**TENDER 16-20**

**WATER TREATMENT BUILDING**

**ADDENDUM NO. 5**

October 7<sup>th</sup>, 2016

**C SECTION**  
SCALE: 1:50

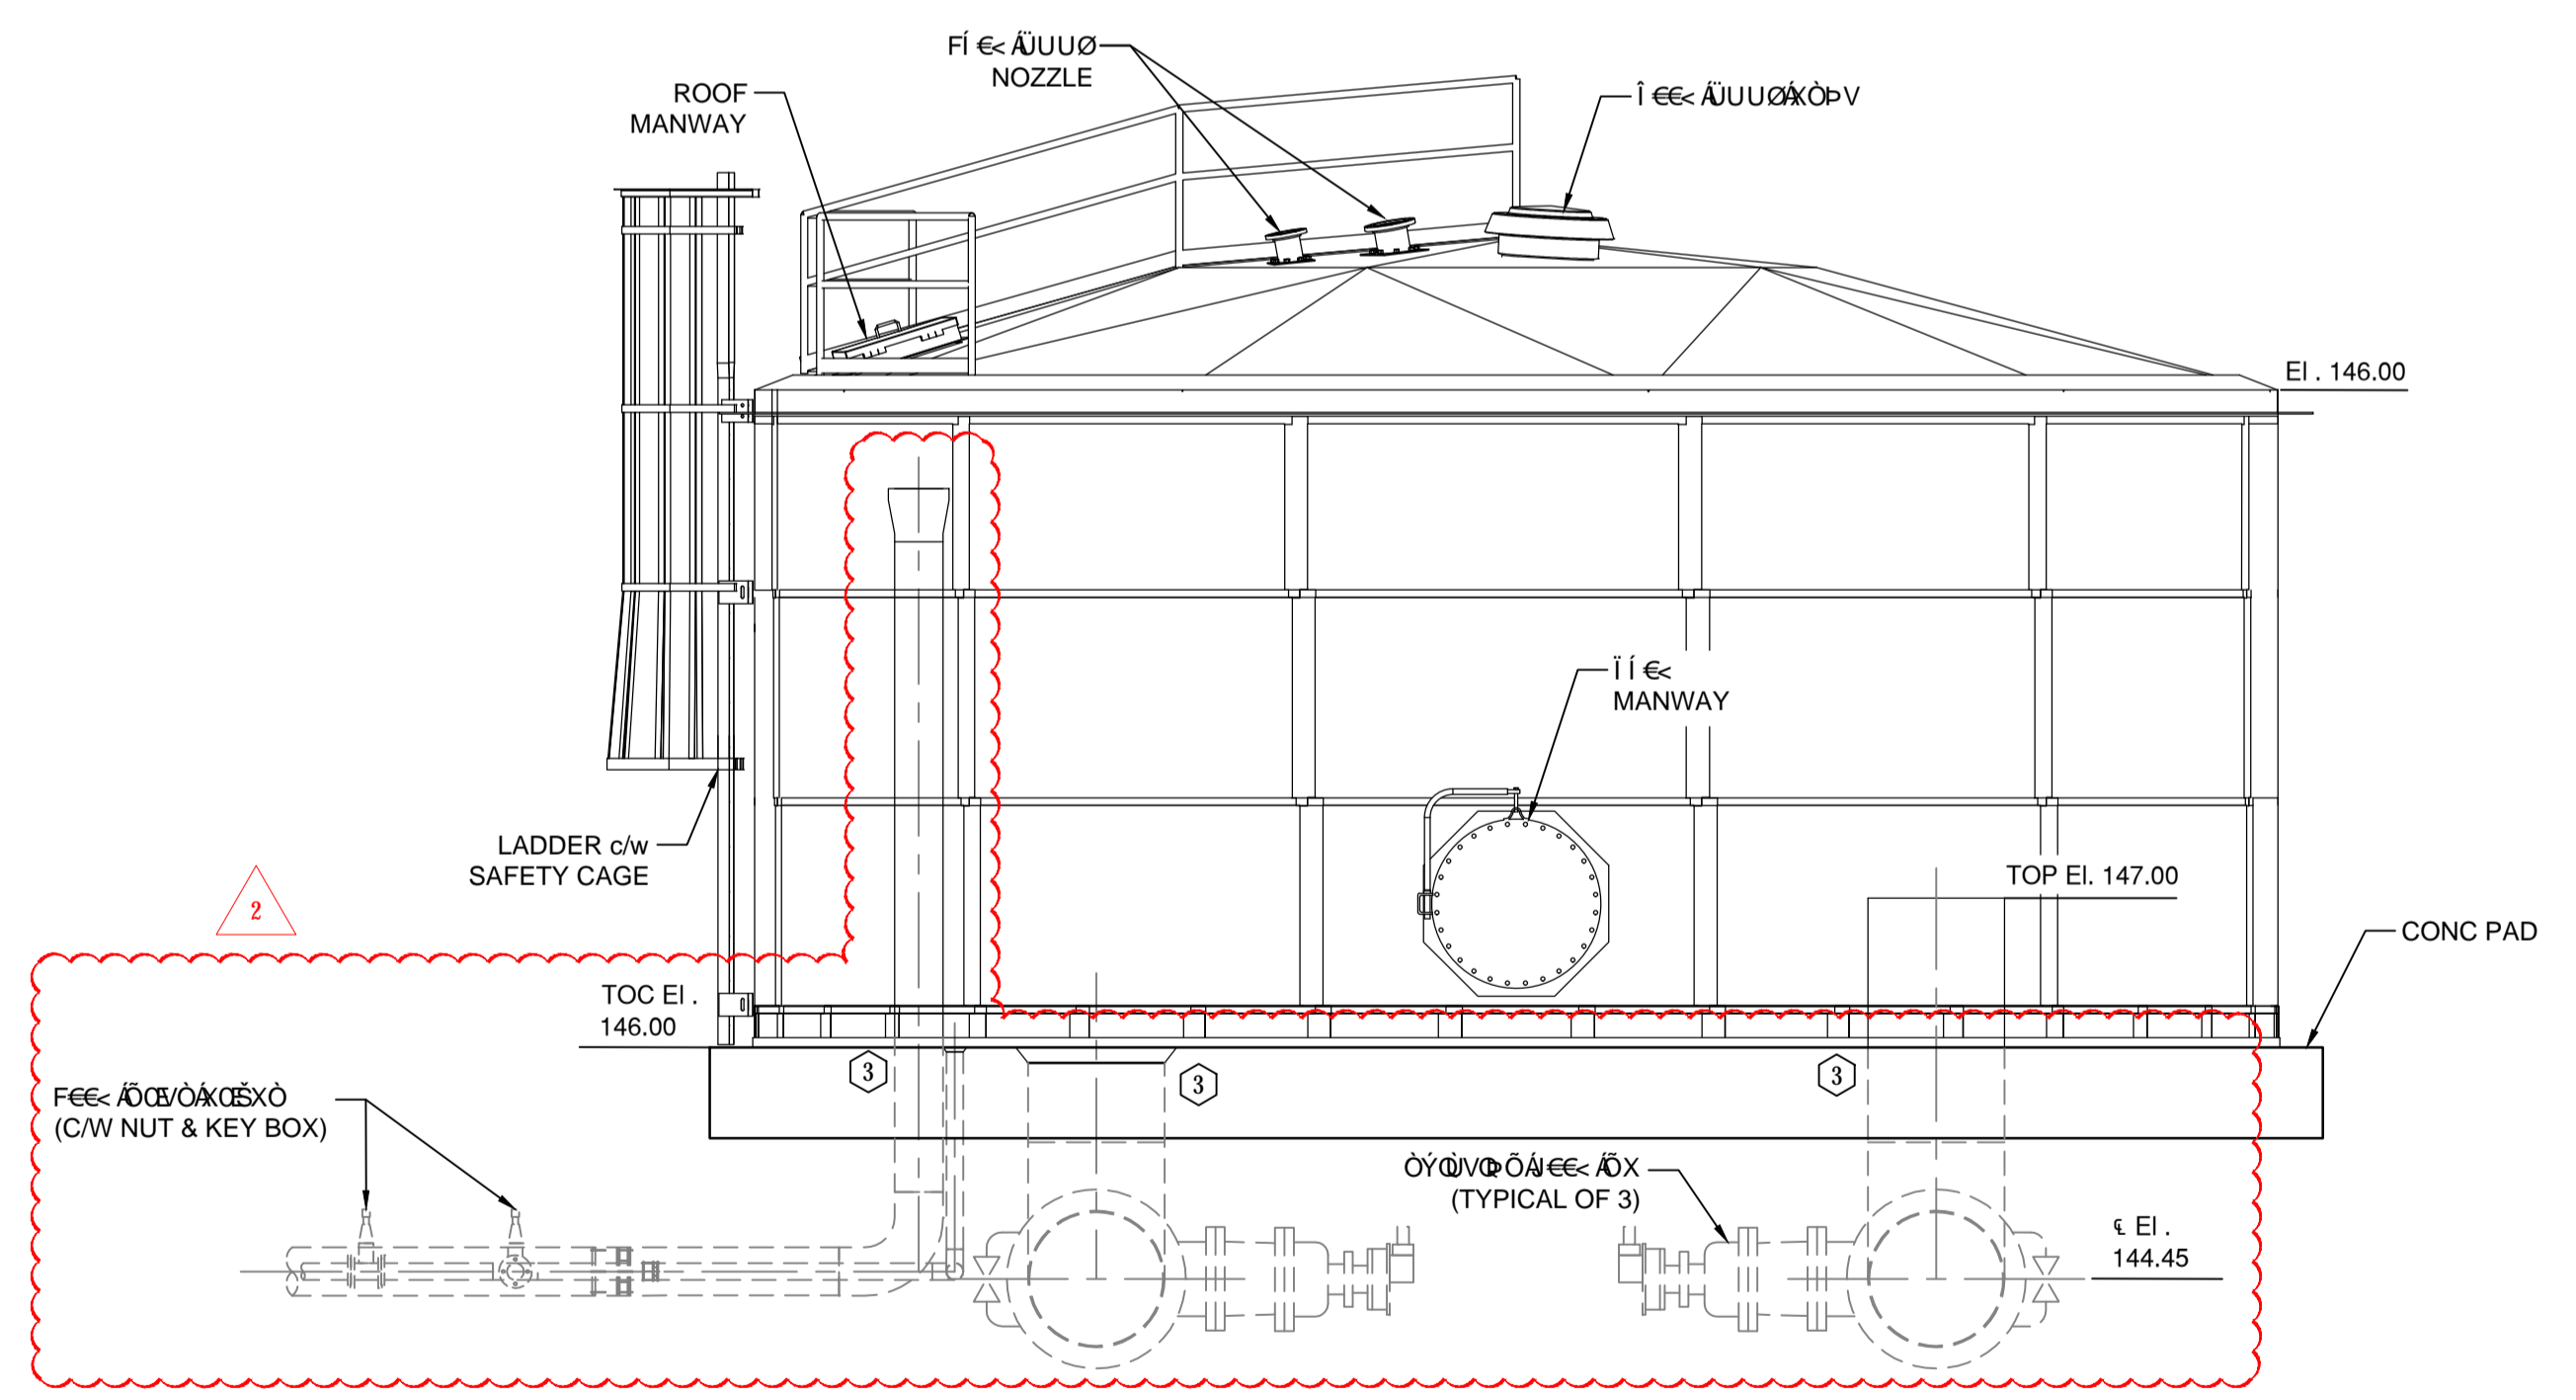
Please provide a civil drawing detailing the piping arrangement and material types for the surge prevention tank. The process piping drawings reference overflow and drain piping that does not appear on civil drawings.
